1-6-24 - Intial Redlines - JJ

168 DC - 174 Duncan Creek Rd., Lillington, NC 27546

**PLAN 4**  
**The Selma RH**  
**'ENGLISH COUNTRY'**

**ARCHITECTURAL DRAWINGS**

**FRONT ELEVATION 'ENGLISH COUNTRY' (SLAB)**

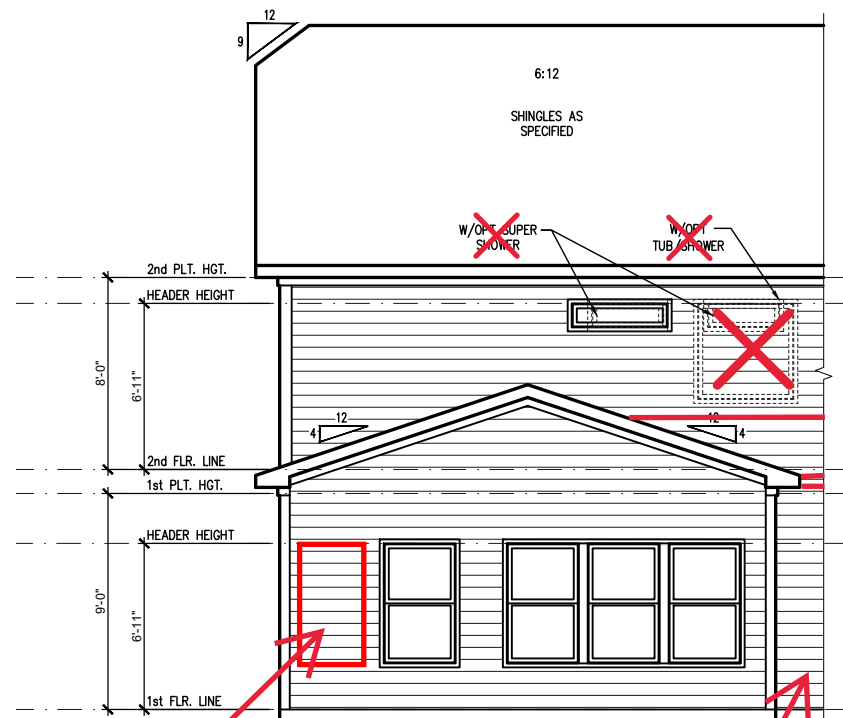
Add 3/0x5/0
